Project	IEEE 802.16 Broadband Wireless Access Working Group < http://ieee802.org/16 >	
Title	Correction to RBIR Link-to-System Mapping in 802.16m Evaluation Methodology	
Date Submitted	2008-07-07	
Source(s)	Yoav Levinbook, Ramon Khalona NextWave Wireless	Voice: 1-858-480-3172 E-mail: (ylevinbook, rkhalona)@nextwave.com * http://standards.ieee.org/faqs/affiliationFAQ.html >
Re:	Change request for document 802.16m-08/004r2	
Abstract	This document describes a problem encountered in the 16m EVM Link-to-System Mapping (RBIR, Section 4) and a remedy to solve the problem	
Purpose	Discuss and adopt	
Notice	<i>This document does not represent the agreed views of the IEEE 802.16 Working Group or any of its subgroups. It represents only the views of the participants listed in the "Source(s)" field above. It is offered as a basis for discussion. It is not binding on the contributor(s), who reserve(s) the right to add, amend or withdraw material contained herein.</i>

Correction to RBIR Link-to-System Mapping in 802.16m Evaluation Methodology

1. Purpose

The purpose of this contribution is to document a change request necessary to correct an error in the mandatory Link-to-System Mapping method

Figure 1. RBIR vs. SINR for QPSK in the SISO case

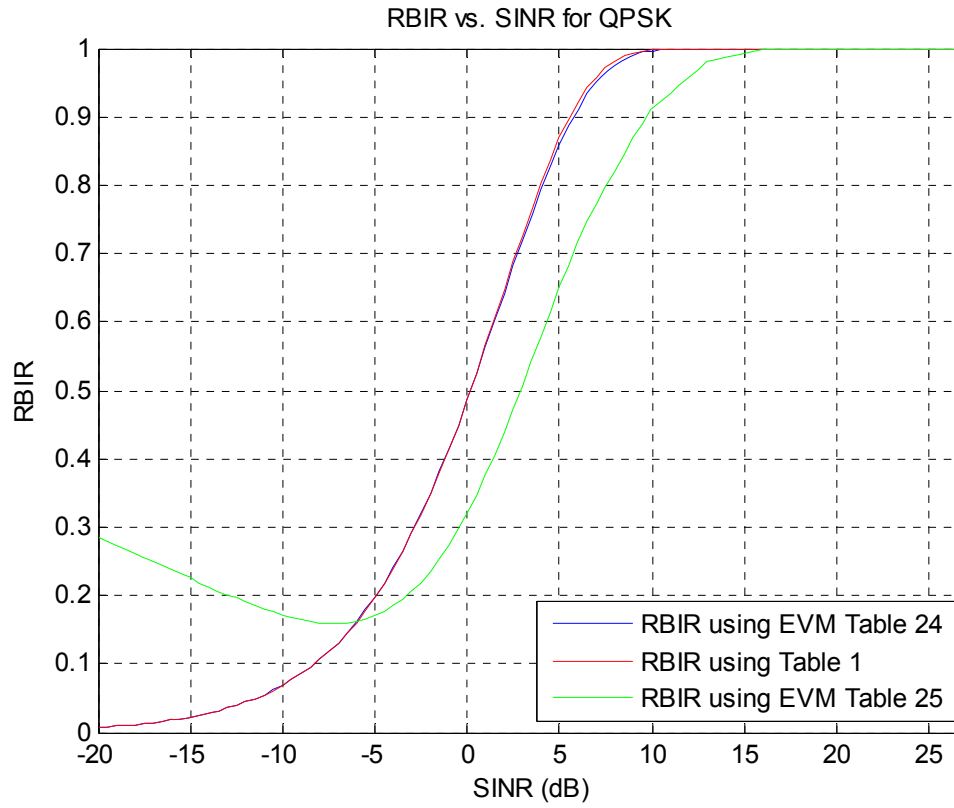
In the SISO case, since the LLR depends only on the SINR, a lookup table for AVE and VAR can be calculated and used. An attempt to generate such a table was done in Table 25 in [1]. It is important to note that currently there is an error in that table. Indeed, if the RBIR is plotted based on this table, by performing the integration in (4.1) numerically, the RBIR is not even monotonic (see Fig. 1 below), which means that in a certain region of SINR, we may decrease the transmit power and have better performance! Observing Appendix Q in [1], the error follows from lines 12 and 19 in pp. 161, which are the expressions for $E(K_1)$ and $E(K_1^2)$.

The error is, in fact, in eqn. (1.13) in [2]. In order to calculate these expectations, it is necessary to perform double integration, but there is an error in the derivation and a one dimensional integral is performed instead.

Using the corrected table (see Table 1 below), we can compare the RBIR calculated using Table 24 in [1], which calculates RBIR directly from the definition, not using the mean and variance of the LLR, the RBIR using Table 25 in [1], and the RBIR using Table 1 below. Certainly, the RBIR vs. SINR plot should be similar whether the calculation is done by the direct method of Table 24 in [1], or using the Gaussian approximation for the LLR. It can be seen that this is indeed the case once the corrected table (Table 1) is used.

Now, with the corrected expression a new table for AVE and VAR can be generated.

Figure 2. RBIR vs. SINR for QPSK in the MIMO case: numerical integration vs. tables in the EVM

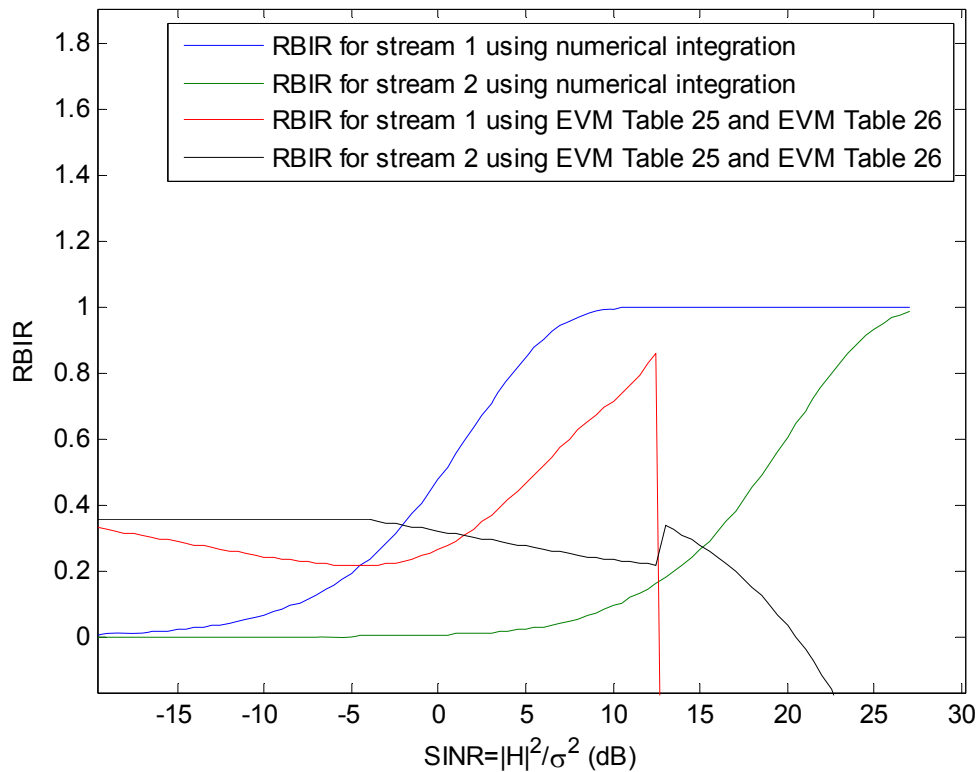
It can be seen that the RBIR calculated using Tables 25 and 26 in [1] does not match the correct one using numerical integration as described in Section 3. In fact, the behavior of the RBIR calculated from Tables 25 and 26 is anomalous since it is not monotonically increasing and suffers from discontinuities because of the use of the factor ‘ a ’. Moreover, in some regions the curve is not even positive!

Fig. 3. RBIR vs. SINR for QPSK in the MIMO case: numerical integration vs. Table 1 and EVM Table 26

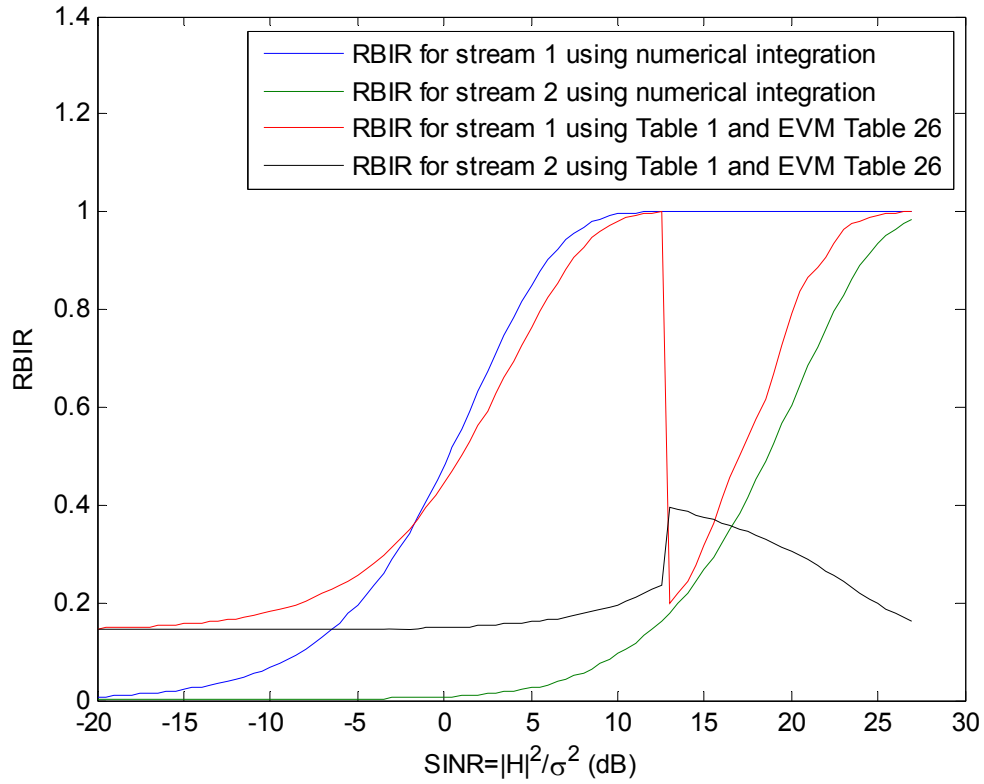
Since we already know that Table 25 in [1] is erroneous, we use Table 1 instead of Table 25 in [1], but still use the factor ‘ a ’ as described in Table 26 in [1] to get Fig. 3. It can be seen that RBIR calculated using these tables is still significantly different than the one using numerical integration and that some anomalous behavior is still

Figure 4. RBIR vs. SINR for QPSK in the MIMO case: numerical integration vs. Table 1 (small α)

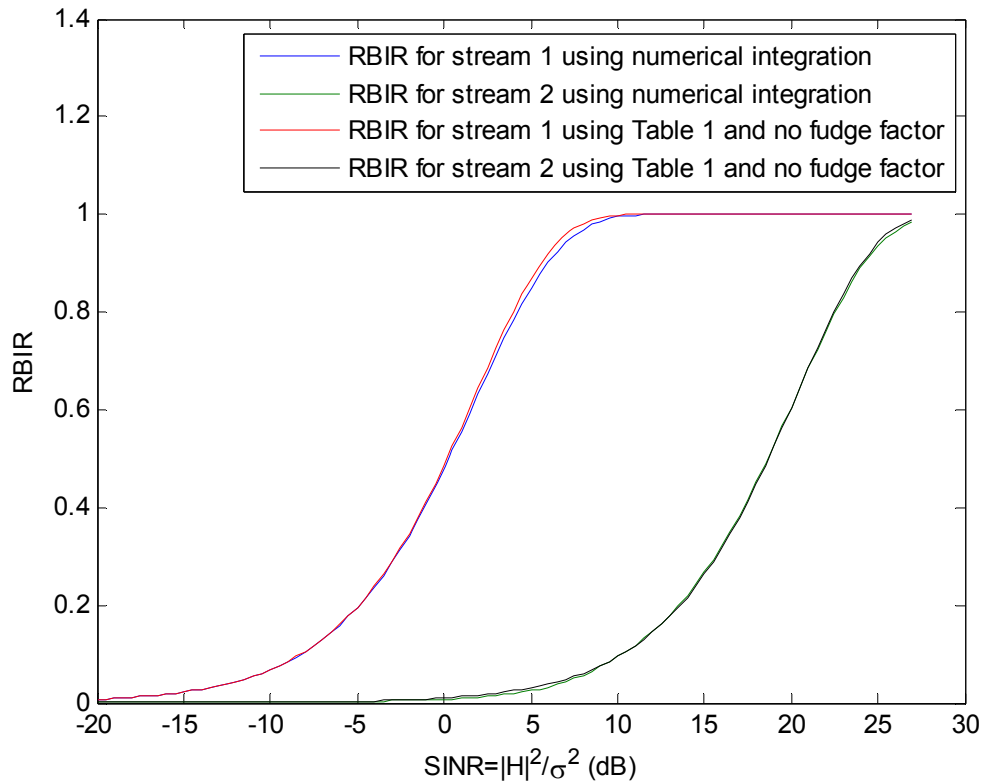
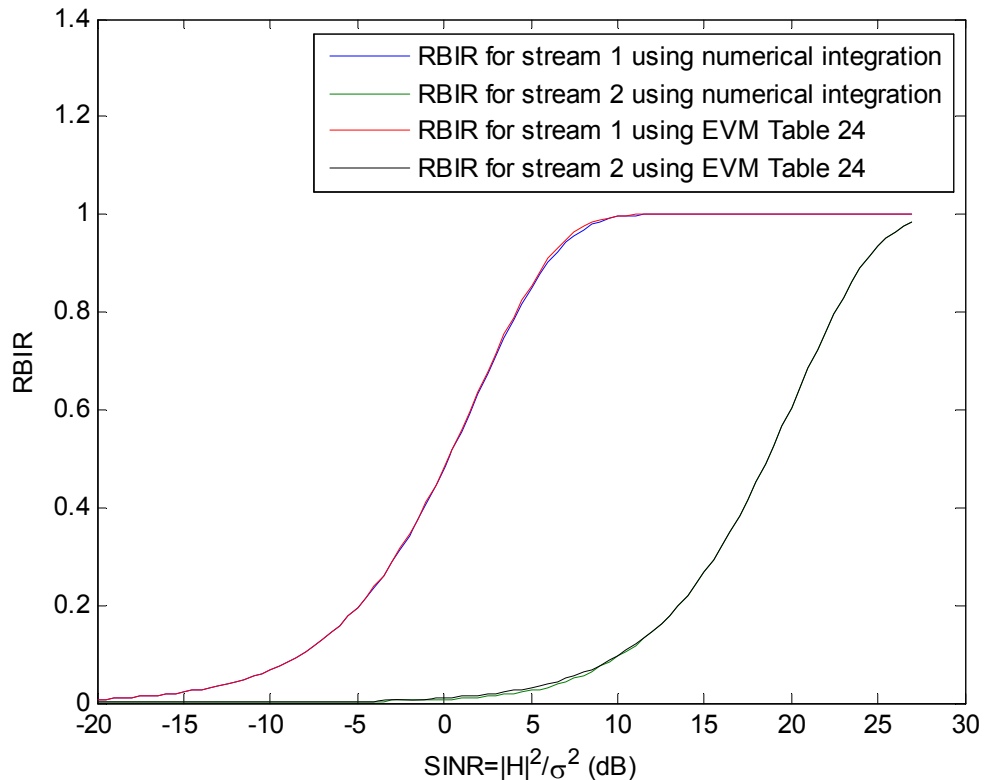
Finally, we use just Table 1 with no fudge factor ‘ a ’ to get Fig. 4. Note that for the chosen channel $\frac{\alpha}{\sigma^2}$ is small for low and moderate SINR φ since $\frac{|H_2^H H_1|}{|H|^2} = 0.09$. Hence we expect to have a good approximation of the RBIR when Table 1 is used. It can be seen in Fig. 4, that for both streams, the RBIR curves generated using Table 1 are very similar to the ones calculated using numerical integration.

In Fig. 5, we show that if we calculate the RBIR for the first and second streams using Table 24 in [1] as described above, we get a very similar figure to Fig. 4.

It is important to note that although Table 1 provides good results when α is small, there is no reason to use the approach of calculating the RBIR using the mean and variance of the LLR. Indeed, Table 24 in the EVM [1] can still be used if the ‘SINR’ parameter in this table is replaced by SINR_1 and SINR_2 for the first and second streams, respectively, where SINR_1 and SINR_2 are defined as $\varphi_1 = \frac{|H_1|^2}{\sigma^2}$ and $\varphi_2 = \frac{|H_2|^2}{\sigma^2}$, respectively.

Figure 6. RBIR vs. SINR for QPSK in the MIMO case: numerical integration vs. EVM Table 24 (moderate α)

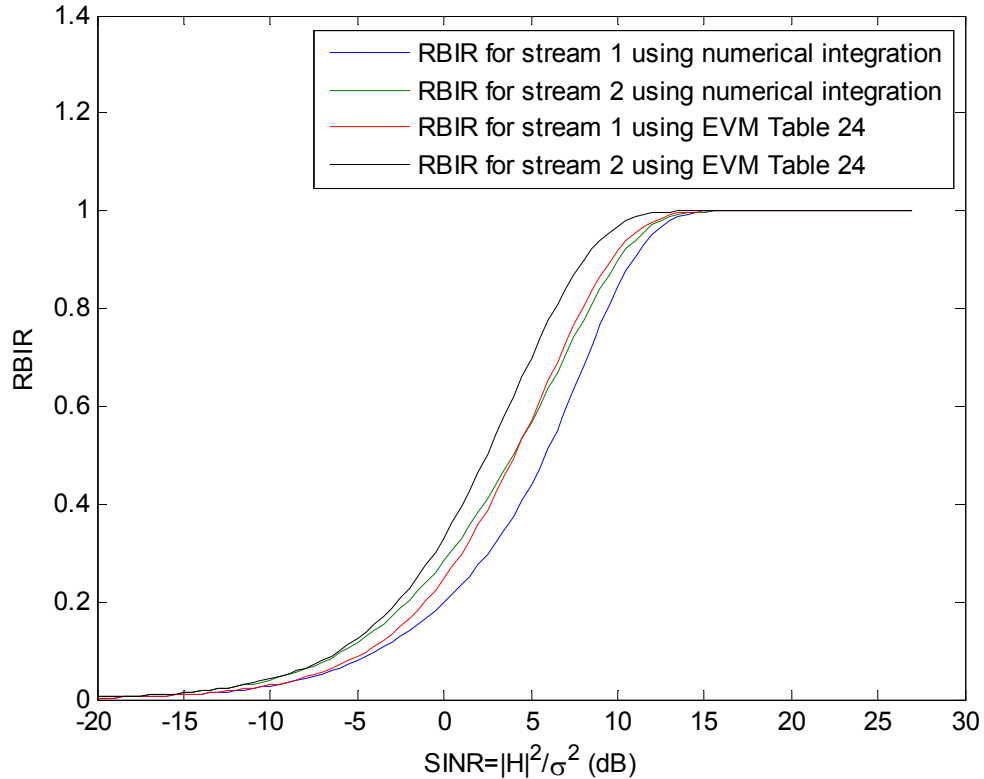
We emphasize that when α is not small, the approximation of $I(Y, x_1)$ by $I(Y, x_1 | x_2)$ may not be accurate anymore and hence using Table 24 in [1] or Table 1 as described above may not give us accurate results.

Consider the following channel as an example: $\bar{H} = \begin{bmatrix} 0.1078 + 0.4358i & -0.6675 - 0.2584i \\ 0.4487 - 0.0798i & -0.2796 - 0.0168i \end{bmatrix}$. In this normalized channel matrix the columns of the channel from the previous example are scaled (i.e., columns H_1 and H_2 are weighted by α_1 and α_2 , respectively). In this case $\frac{|H_2^H H_1|}{|H|^2} = 0.38$ and α is larger than in the previous example. As can be seen in Fig. 6, the RBIR curves calculated using Table 24 in [1] (i.e., assuming the small α approximation) differ from the correct RBIR curves, calculated using numerical integration.

Thus, in general, except for the case of small α , RBIR in the MIMO case should be preferably calculated using the numerical integration method of Section 3. Of course, it would be very useful to derive an approximation that would enable us to use a simple lookup table, but this approximation should hold in all cases of interest and not only for the case of small α .
